**PLANNED UNIT DEVELOPMENT  
STAFF REPORT**

**Date: March 19, 2015**

Grant Harkness

Planned Unit Development Approval to amend a previously approved Planned Unit Development to allow an additional building.

# SITE PLAN

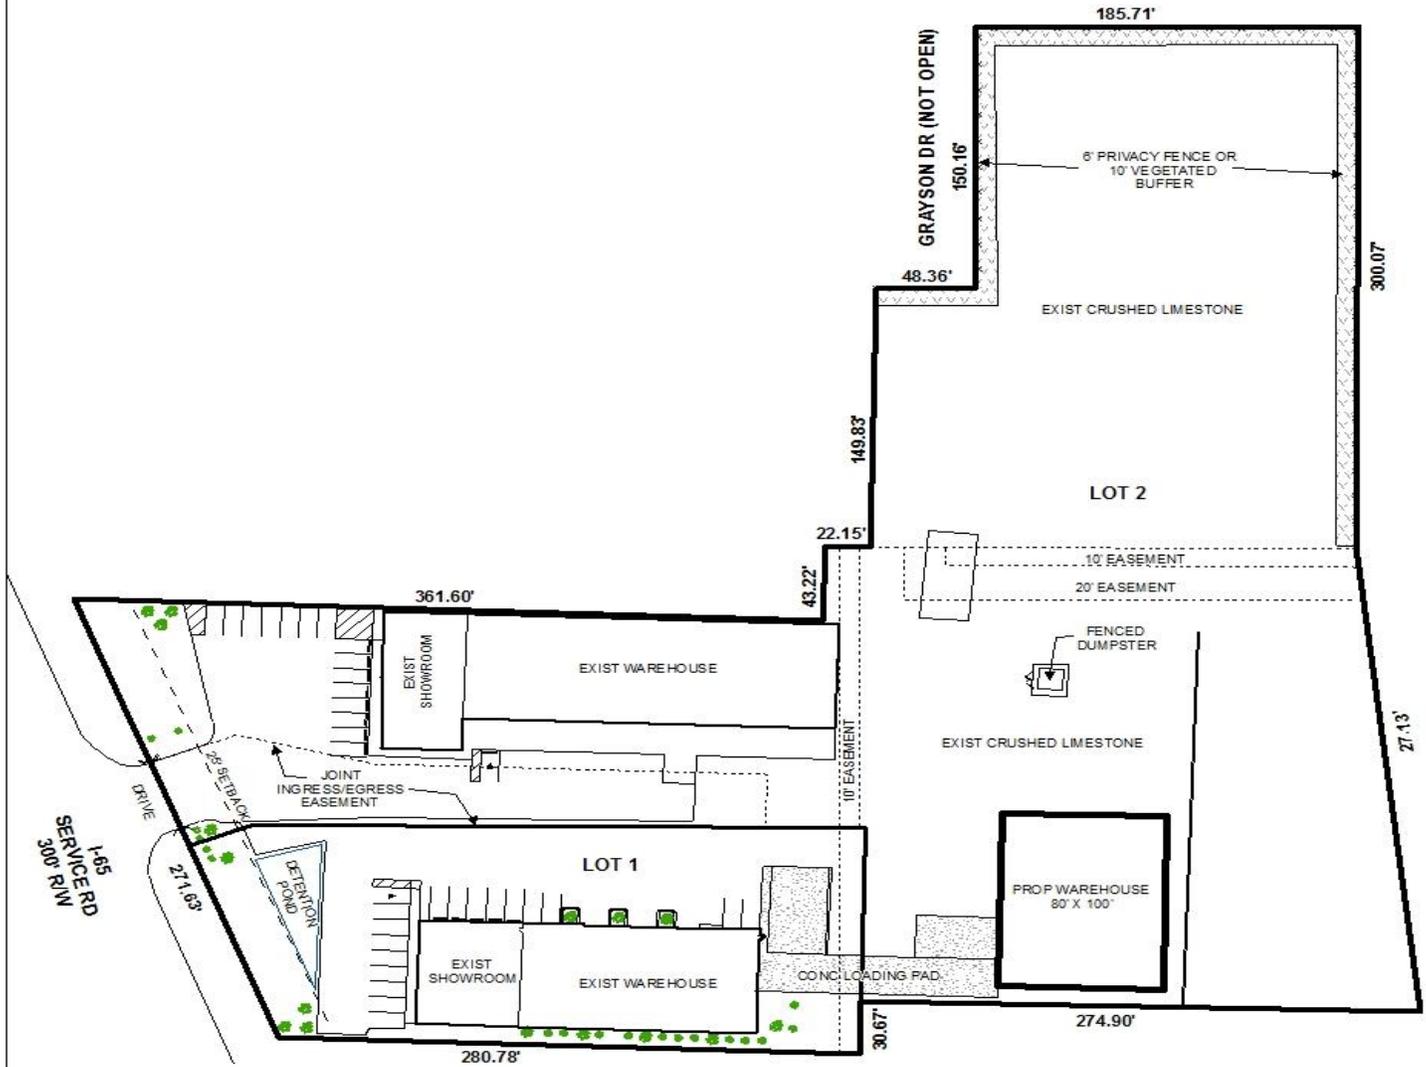
The site plan provides information regarding parking on Lot 2, but does not include Lot 1. Based on the existing 3,000 square foot showroom and warehouse, it appears that Lot 1 will have sufficient parking as long as there are no more than 24 warehouse employees. The site plan should be revised to include parking calculations for both lots.

No new tree plantings are proposed for the site, and the submitted site plan matches previously approved tree plans for the site; however Lot 2 was previously required to have frontage trees only. Because the proposed warehouse will result in an increase of more than 50% of building area, Lot 2 should be required to come into full compliance with tree planting and landscaping requirements.

Regarding Lot 2, the site plan indicates that the bulk of Lot 2 is crushed limestone, and it appears to serve as a storage area that has been expanded since 1984, with no apparent permits. It should be noted that while the site did obtain variances to allow gravel surfacing for the parking area in the front of the site, the variance approval expired in 2011, and the applicant did not express a desire to have a gravel storage area on site. All storage areas in B-3, Community Business Districts are required to be paved with asphalt or concrete.

Furthermore, the aerials show that the storage area for Lot 2 contains other buildings not indicated on the PUD site plan, that it appears to accommodate employee parking on gravel surfacing, and that a variety of truck trailers, trucks and other equipment are stored in the rear area: one of the Planning Commission conditions of the approval from 2005 is "*the submission and approval of a Planning Approval application if the heavy equipment rental operation is expanded.*" Thus the applicant should provide a more detailed description of the activities on the site, and should revise the site plan to accurately reflect all existing buildings, and improvement of the entirety of the site to meet paved surfacing requirements of the Zoning Ordinance.

It should be noted that the submitted site plan shows a 10' water and sewer easement as well as a 20' sanitary sewer easement on the rear portion of Lot 2 which was not indicated on any of the previous Subdivision, Planned Unit Development, or Variance site plans. Furthermore, there is an existing building located on top of these easements. Due to the location of the easements, the structure should be relocated, or the easements vacated.

There is a note on the site plan indicating that preservation status will be granted to “the 42” Live Oak Tree located on the North side of Parcel A”. There is no such tree illustrated on the site plan, nor has Urban Forestry made such a stipulation for this site. If this note was indeed placed on the site plan by mistake, it should be removed.

**Planned Unit Development:** Based upon the preceding, this application is recommended for Holdover until the April 16, 2015 meeting, with revisions due by March 27, 2015, so that the following revisions to the site plan can be made:

- 1) revision of the site plan to show all existing buildings on the site, and label their use and size;
- 2) revision of the site plan to show full compliance with the paving requirements of the Zoning Ordinance;

- 3) revision of the site plan and provision of a written description that describes the storage area for Lot 2 – the types of vehicles and equipment kept in the area;

- 4) submission of a Planning Approval application if heavy equipment is being stored on site for rental purposes;
- 5) illustration of full compliance with tree planting and landscaping requirements for both lots;
